National Competitive Procurement for Construction of Maniyafushi Mariculture Research and Development Facility

Reference Number: (IUL)13-K/13/2018/155
Project Number: TES/2018/W-26

New scope of work

Schematic diagram of sewage treatment plant connections with emergency outfall

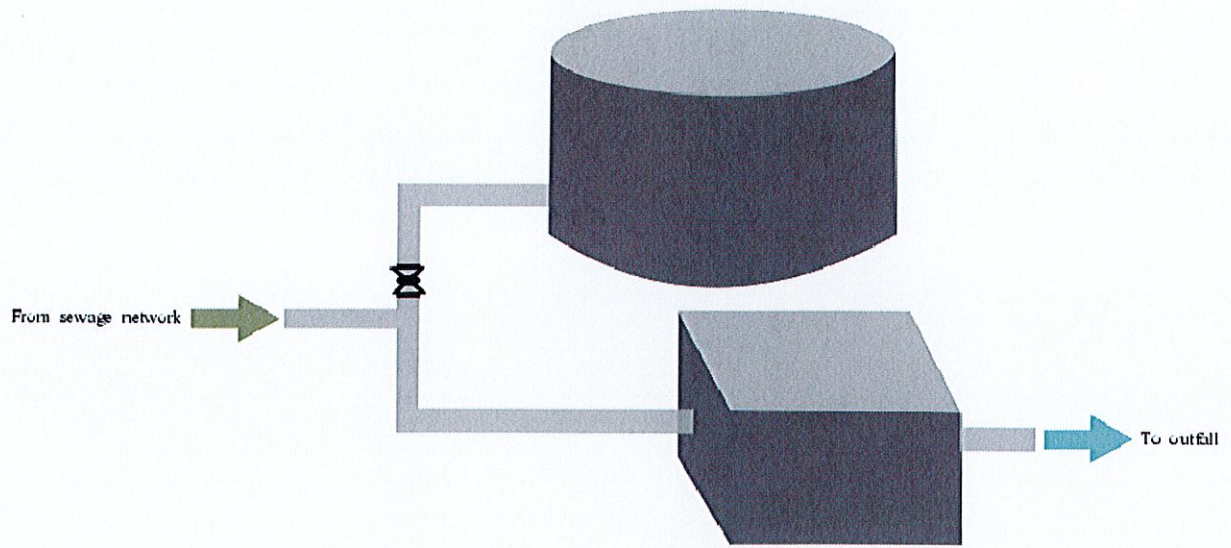
Sewage treatment plant installation, connecting to the sewer network, and extension of sewage outfall pipeline

1. The contractor shall provide the specification for an activated sludge sewage treatment plant suitable for a facility with a maximum of 50 individuals at any given time
2. The contractor shall obtain any authorisations required for the installation and operation of the STP.
3. The contractor shall procure and install the sewage treatment plant upon approval from the client.
4. All house plumbing (except for the hatchery waste water) should be connected to the sewage treatment set up
5. The contractor shall estimate the lengths of pipelines in the sewage network based on the information provided.
6. The sewage treatment plant should be connected to the existing septic tank and outfall set up, so as to allow for an emergency outfall
7. The existing outfall pipe should be extended by a length of 550 ft, so that the outfall is extended off the reef edge

Hatchery deck details

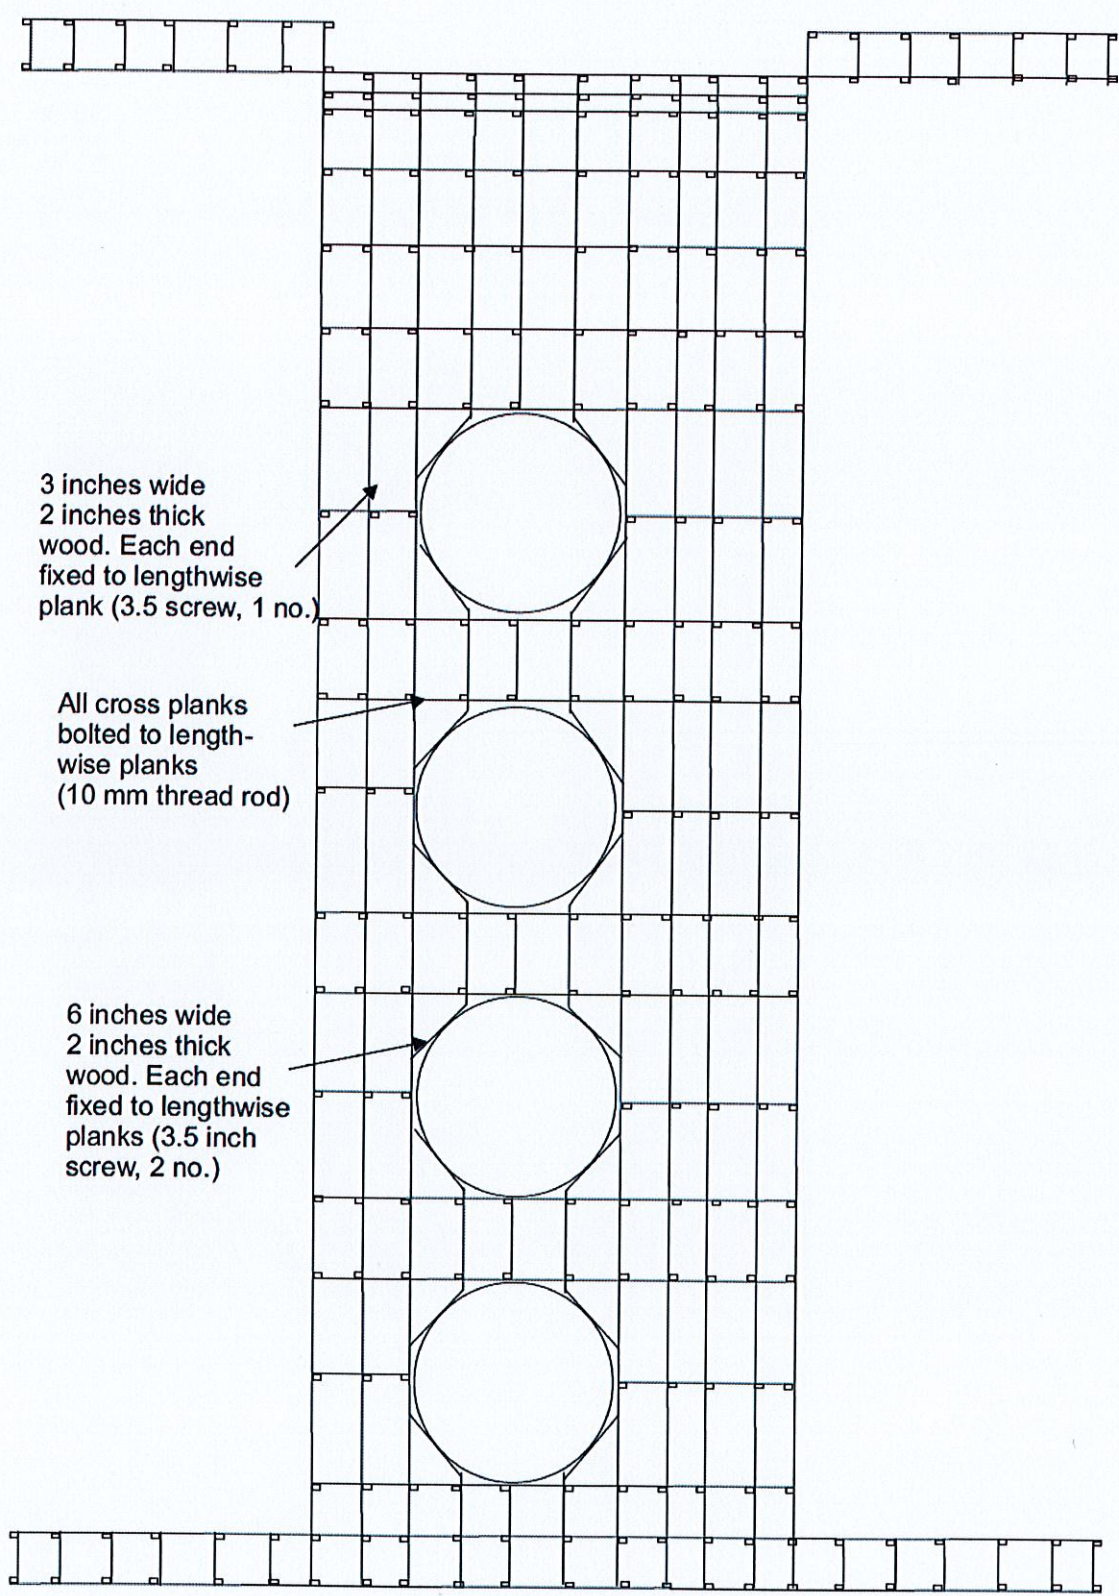
1. The contractor shall construct a wooden deck to cover the remaining portion of the hatchery in accordance with the schematic provided (size: 4424mm x 20,593mm, and four sides of the existing deck with size: 1000 mm x 4,253 mm, marked "new deck" on the diagram in dark grey shade), using marine plywood 18mm in thickness.
2. The frames of the deck shall be constructed with 2" x 6" timber.
3. The entire deck (both the old and the newly constructed) shall be triple coated with fiberglass mats and double coated with epoxy paint (blue colour).
4. The contractor shall construct two wooden steps measuring 4424 mm (length), 12" x 8" steps, triple coated with fiberglass mat and double coated with Epoxy paint.

L: Excess hole lid 1212 x 1000. Both side fibre-coated.
2 grooves at both ends to insert handles. 8 SS handles to be provided.

Schematic of the hatchery wastewater treatment area

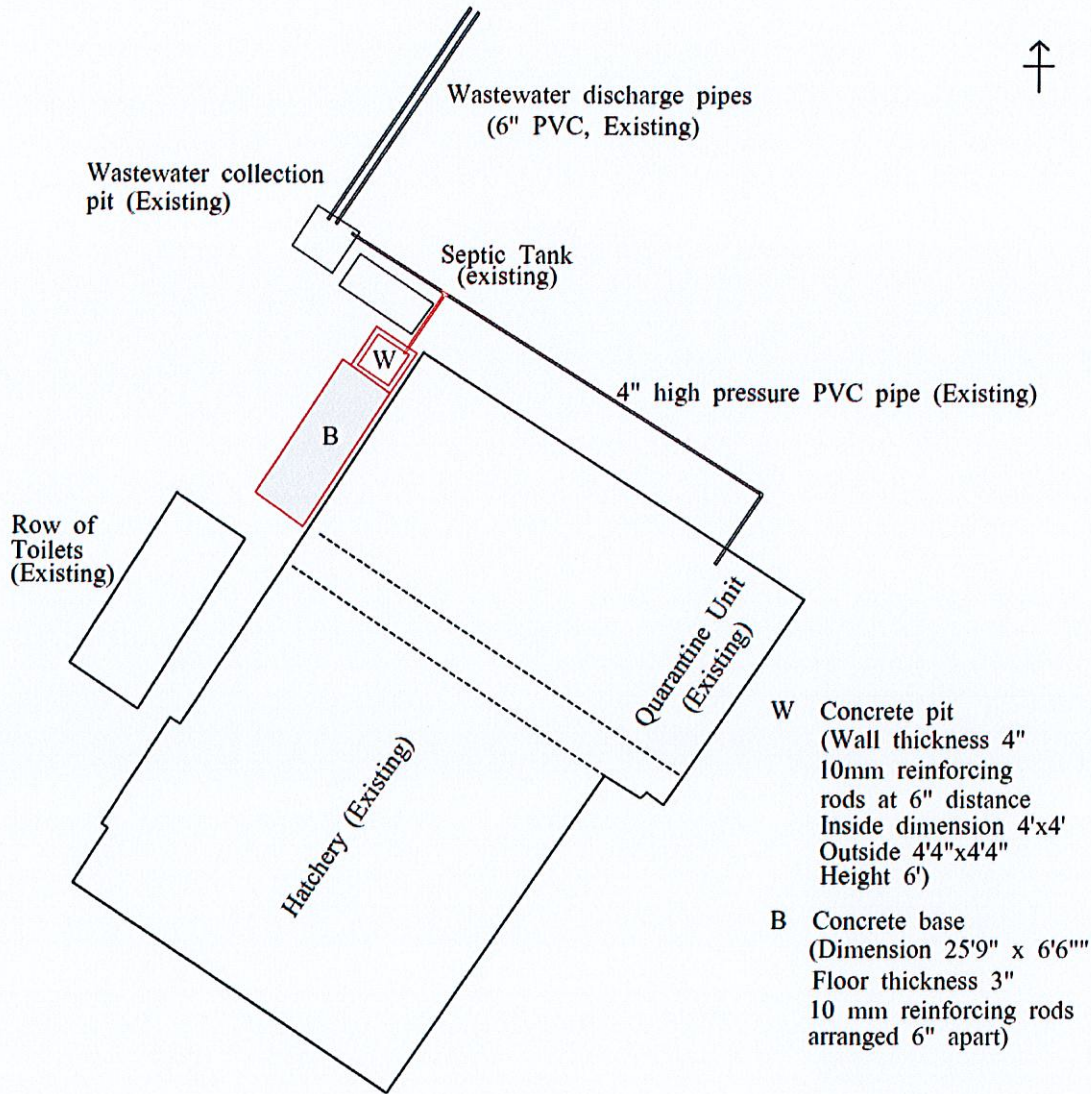
1. The contractor shall fill the existing underground concrete tank measuring 12.5'x8'x4'10", with sand or small debris generated from the demolition works

2. The contractor shall fill the existing underground concrete tank inside the Quarantine Unit of the Hatchery, measuring 5'9"x 4'9" with sand or small debris generated from the demolition works

3. The contractor shall construct a 25'9" x 6'6" concrete floor at 3" thickness, with 10mm reinforcing rods arranged 6" distance apart.
4. The contractor shall place fiberglass tanks provided by the client on the concrete surface constructed

5. The contractor shall construct the concrete pit (marked "w" on the schematic)
6. The contractor shall connect the two fiberglass tanks together with high pressure PVC pipe (2")

7. The contractor shall fix a 4" ball valve on the existing pipeline (4" pipe at ground level) coming from the quarantine unit to the existing wastewater collection pit. The contractor shall connect this pipeline (at ground level) to the concrete pit (w) with 4" high pressure PVC pipe. There shall be a 4" ball valve on the pipe

8. The contractor shall install an electrical pump (P) to pump water from the waste water collection pit (w) to the fiberglass tanks (pipe H high pressure 2"pvc pipe, foot valve, union connection). The pipeline shall be buried at 6" depth except the foot valve end and fiberglass tank end

9. An elbow and standpipe of height 8' (standpipe removable) shall be put on the two existing 6"pvc pipe between the waste water collection pit and reef edge. Water coming from the fiberglass tank should be discharged into these standpipes. The standpipes are supported by two GI pipe (1.5" dia) poles (height 10', 3' in concrete base). Standpipes are clipped to two horizontal GI pipes (1.5" dia., length 5') fixed to the poles.

Schematic of the new intake wells and connections to the existing well

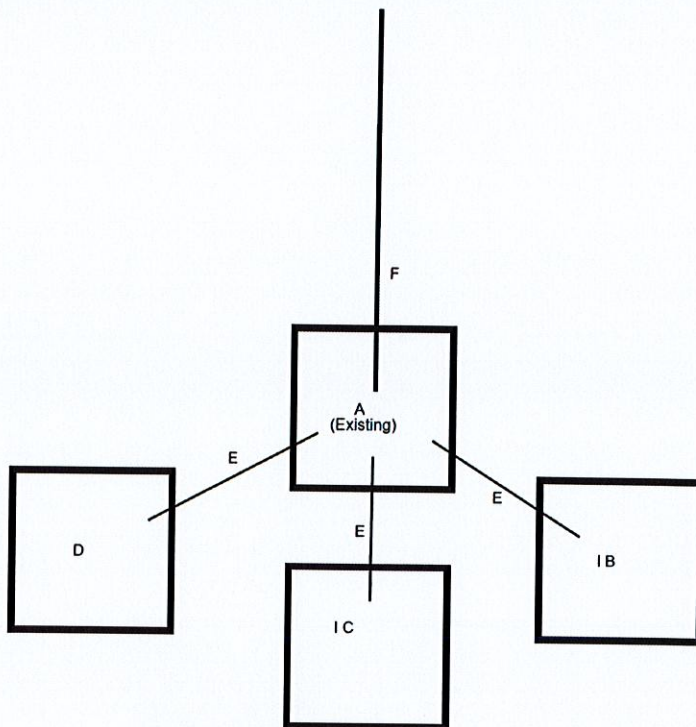
1. The contractor shall construct three concrete wells, measuring 4' 5" x 4' 5" x 8' height (marked B, C and D on the diagram, well A and intake pipe F existing) with a wall thickness of 5 inches. The wells should be reinforced with 10 mm reinforcing rods at 6" x 6" distance. The inside dimensions of the wells should measure 4' x 4'
2. The contractor shall deploy the wells on the lagoon side of the existing well and connect the wells to the existing well A using 9' length of 4" high pressure PVC pipes. The connection is at the bottom. A pvc high pressure 4" standpipe should be placed at each end of each bottom connection pipe.
3. Each well shall have a concrete lid constructed in 4 parts, each with a thickness of 3 inches and reinforced with 6mm reinforcement rods laid 4"x 4" apart.
4. The wells shall be open bottom, filled with a 6" layer of coral rubble

A, B, C, D: Concrete wells .
Wall thickness 5 inches
Reinforcing rods 10 mm, 6" x 6" distance
Inside dimension 4 ft x 4 ft
Outside dimension 4ft 5 inches x 4 ft 5 inch
Height 8 ft
E: 4 inc high pressure pvc pipe connecting wells. Length 9 ft
F: 6 inch pvc main pipe going to hatchery (existing)

Schematic of the new intake wells and connections to the existing well

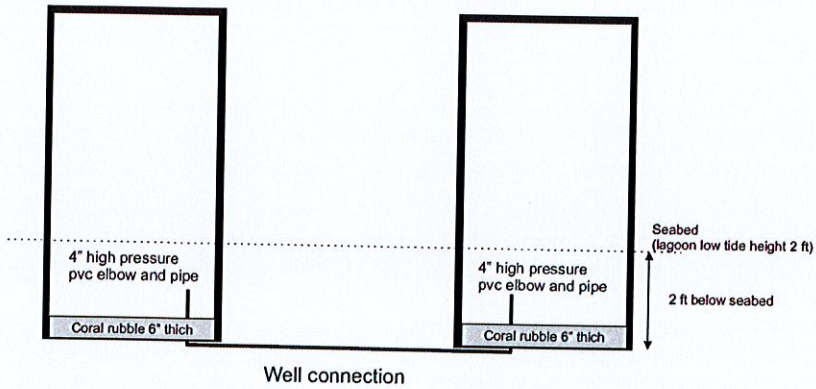
Lid
Concrete lid in 4 parts
Lid thickness 3 inches
Reinforcing rod 6 mm at 4 inch distance
